DOCUMENT CHANGE REQUEST

DCR number	442	Changes required for:	General	Originator:	S Jeffery - ESCC
Date:	2008/11/05	Date sent:	2008/11/05	Organisation:	
Status:	IMPLEMENTED

Title: Transistors Low Power PNP, based on types 2N2894 and 2N2894A

Number:	5202/004	Issue:	1
---------	----------	--------	---

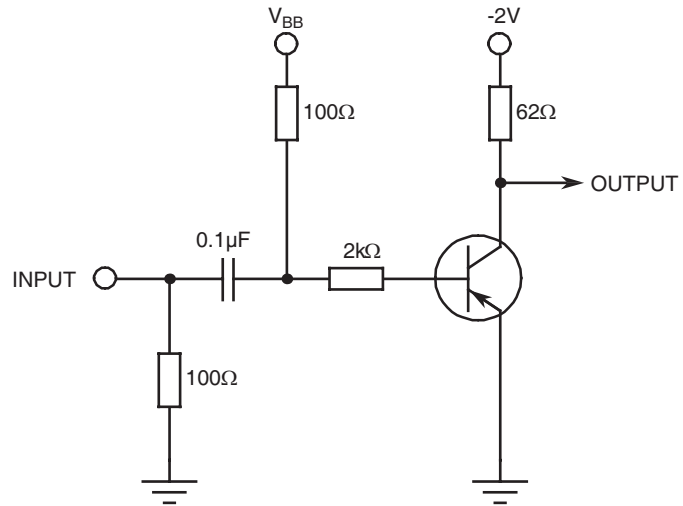
19. Table 2: Figure 4 deleted and incorporated in to a Note to Table 2 (Note 3).
20. Table 2: Replace LTPD7 sampling for AC parameters tests (designated by "Note 2") with an equivalent fixed sample of 32 components with 0 failures (or 100%).

1. Pulse measurement: Pulse Width $\leq 300\mu s$, Duty Cycle $\leq 2\%$
2. For AC characteristics read and record measurements shall be performed on a sample of 32 components with 0 failures allowed. Alternatively a 100% inspection may be performed.
3. t_{on} shall be measured using the following test circuit. The input waveform shall be supplied by a pulse generator with the following characteristics: $Z_{OUT} = 50\Omega$, $t_r \leq 2ns$, Pulse Width = $200 \pm 10ns$, Duty Cycle $\leq 2\%$. The output waveform shall be monitored on an oscilloscope with the following
